**CORRESPONDENCE COVER SHEET  
WASTE PERMITS DIVISION  
TEXAS COMMISSION ON ENVIRONMENTAL QUALITY**

Date: October 20, 2022  
 Facility Name: Twin Oaks Power Station CCR Landfill  
 Permit or Registration No.: CCR112

**RE: Response to TCEQ Technical NOD 2 Correspondence Dated September 22, 2022  
Twin Oaks Power Station Coal Combustion Residuals Landfill  
Major Oak Power, LLC  
Bremond (Robertson County), Texas  
CCR Registration No. CCR112  
TCEQ SWR No. 37677; EPA ID No. TXD987997988  
Tracking No. 27247279; RN100226570/CN604670034**

**WATERSHED MAP - RUN ON ANALYSIS**

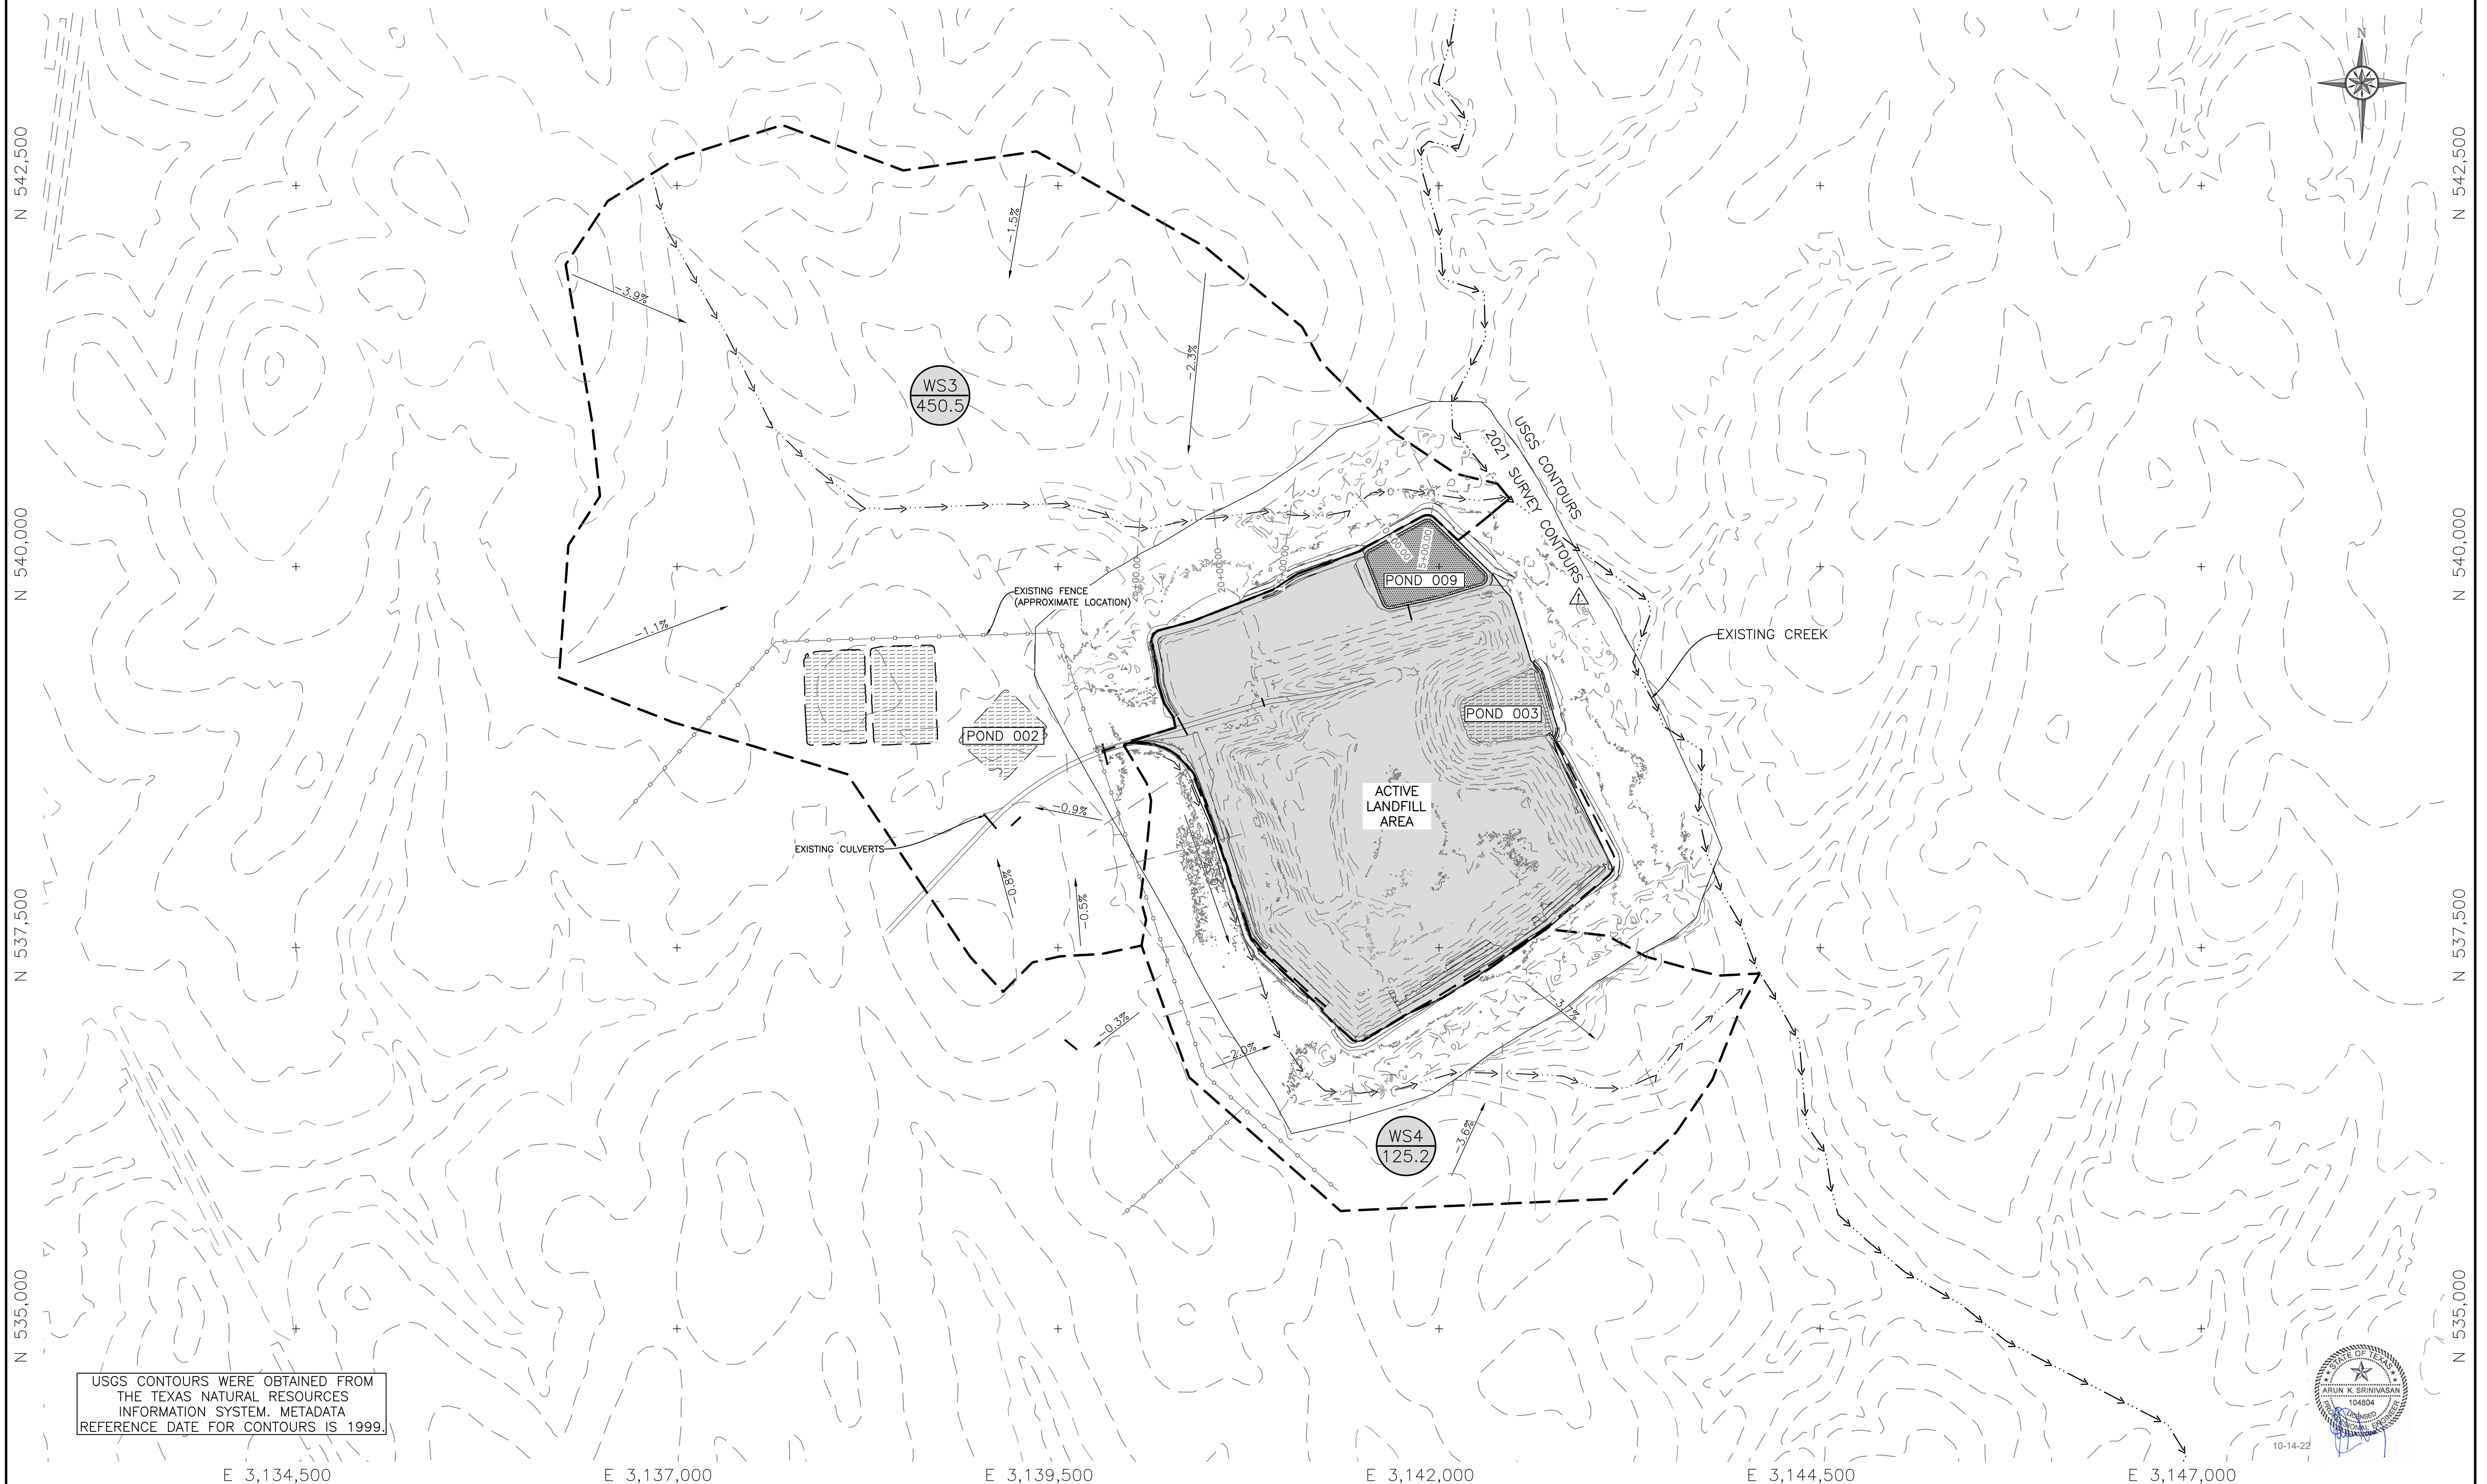
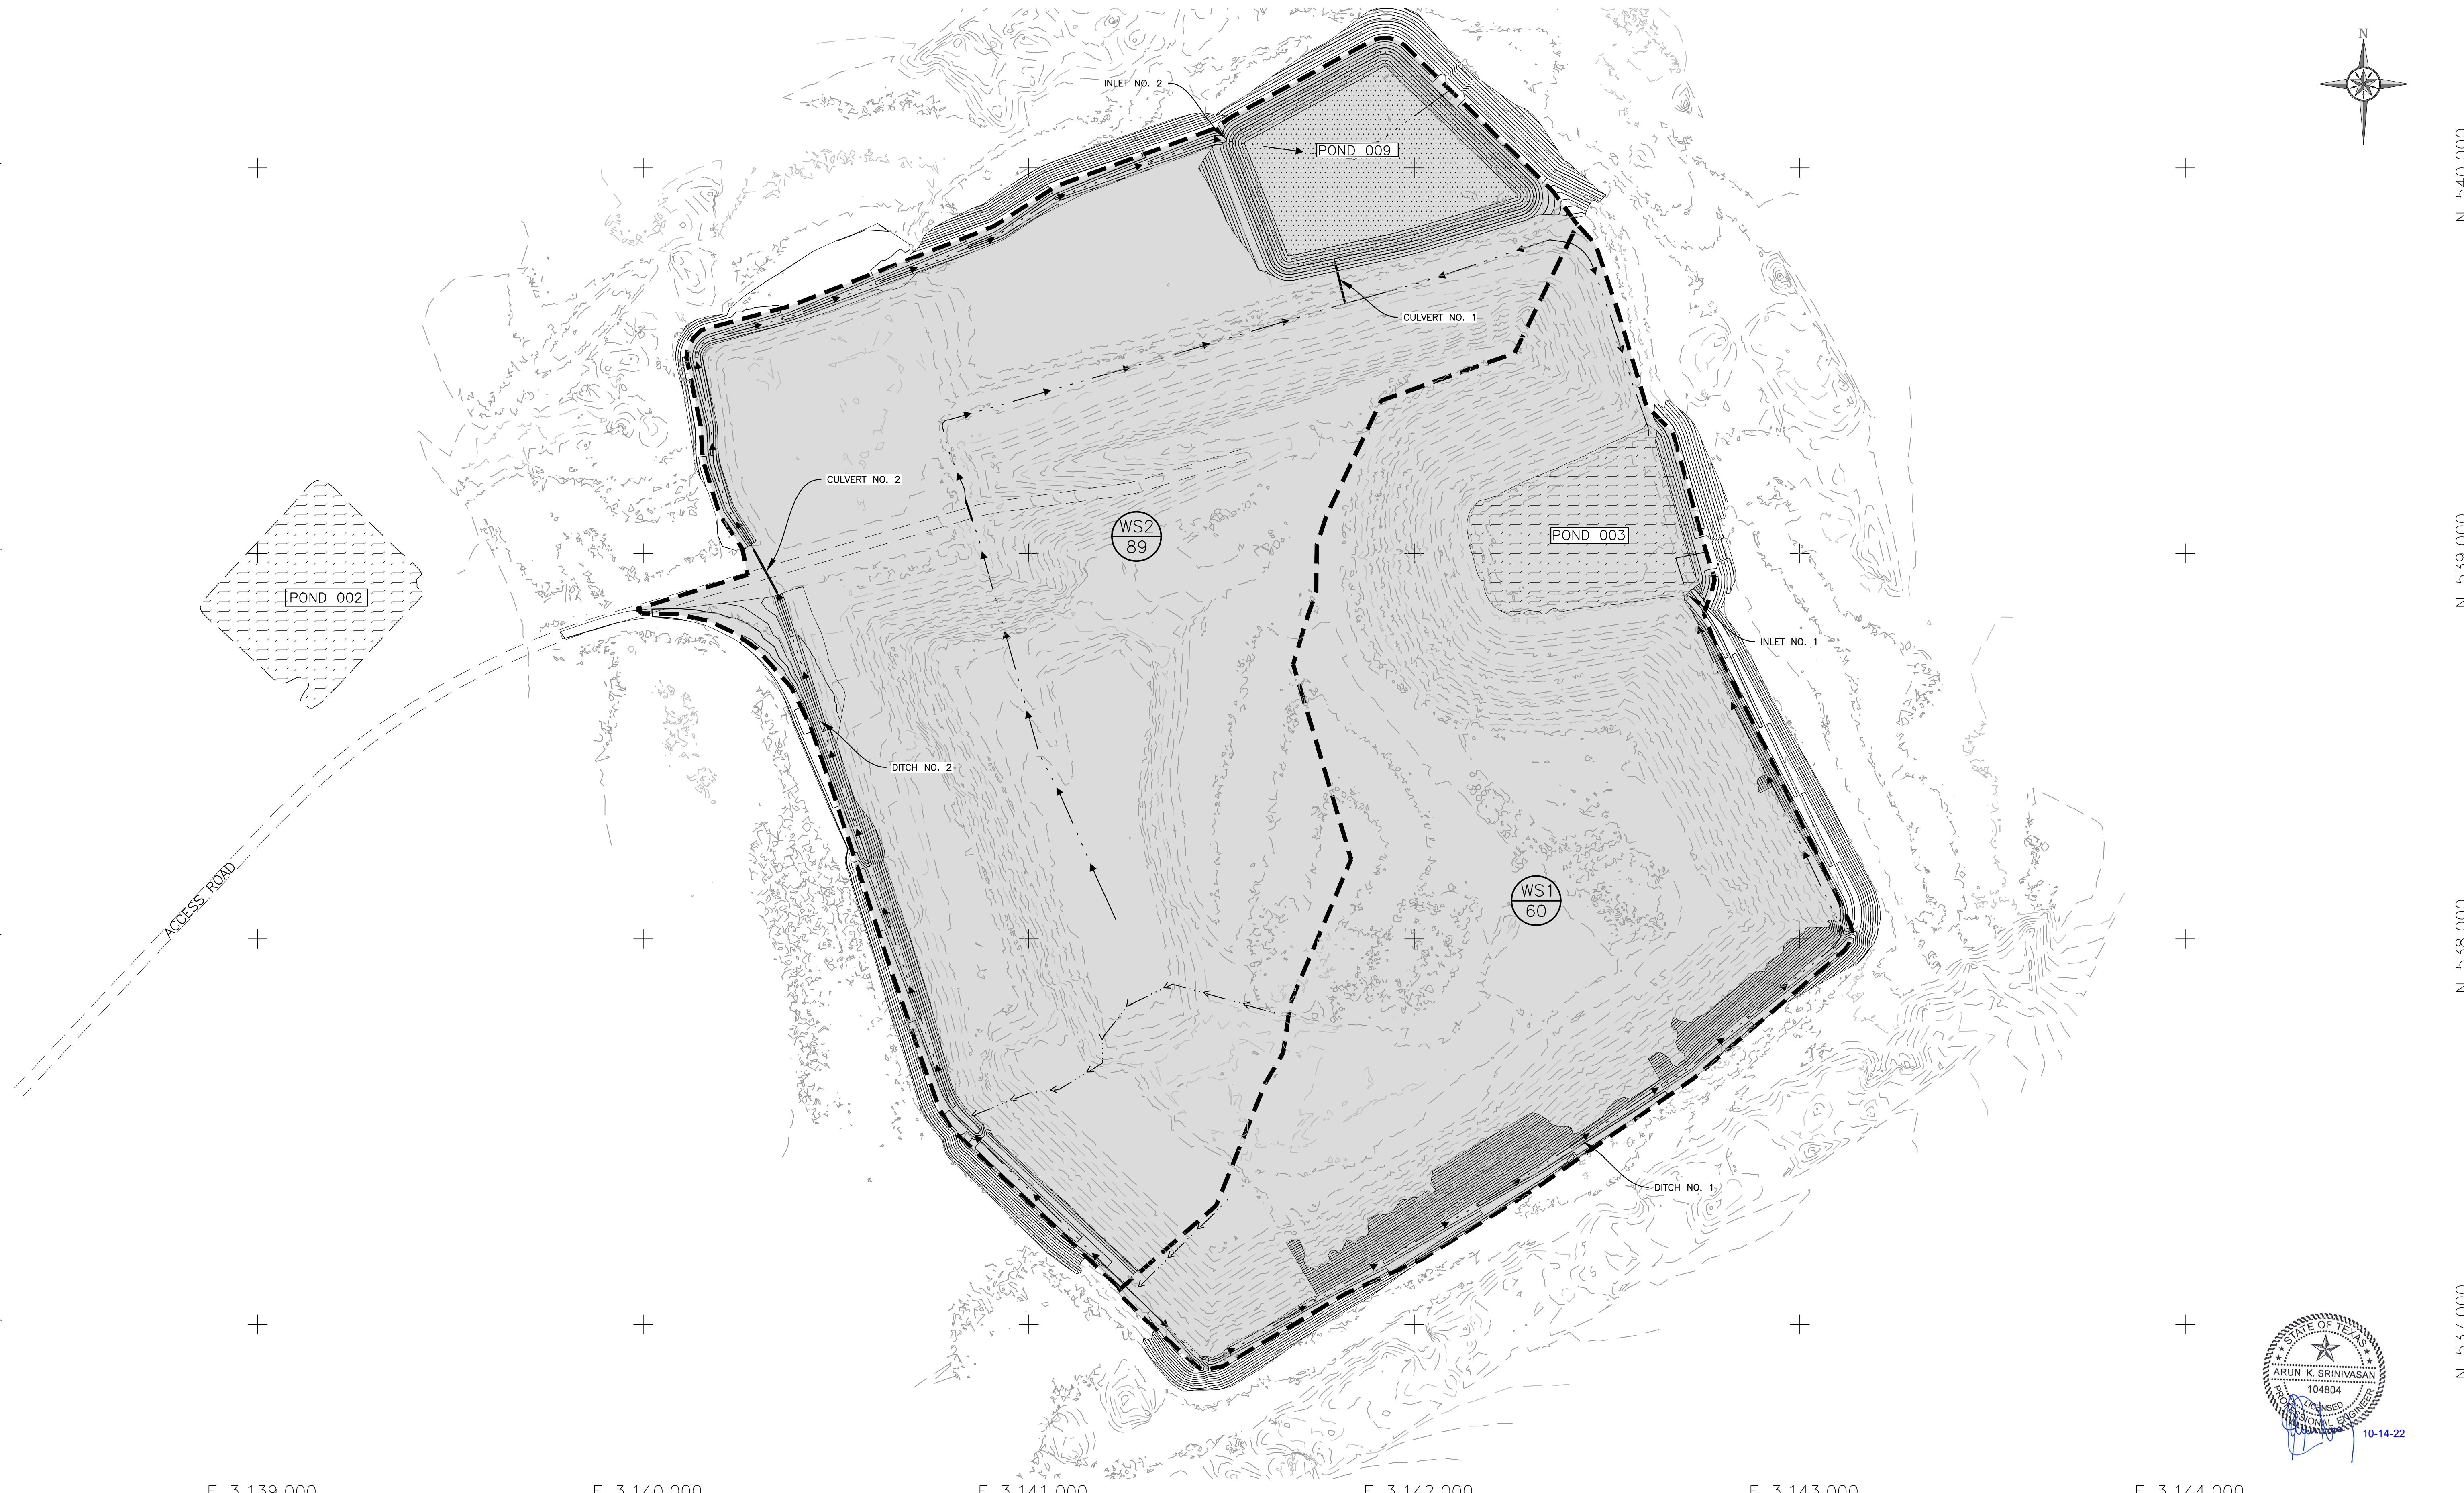
- a. *Provide the appropriate P.G./P.E. seals for the 7 drawings related to the Run-on Run-off Report.*
- b. *Use the most current rainfall data from the National Oceanic and Atmospheric Administration (NOAA) Atlas 14 study for Texas 24 hour-25 year storm event rainfall amounts, and update calculations, HEC-RAS models, Hydraflow models/reports, or any other calculation/model relying on rainfall amount inputs.*

- a. The certified exhibits are included herein.
- b. Storm event data from NOAA Technical Paper No. 40 (provided in the Run-on and Run-off Control System Plan of registration application) was utilized to evaluate the 24-HR/25-YR design storm event for the CCR unit and satisfies the design requirements of §257.81(c), 30 TAC 352.4 and 352.231(c). No updated calculations are provided herein.
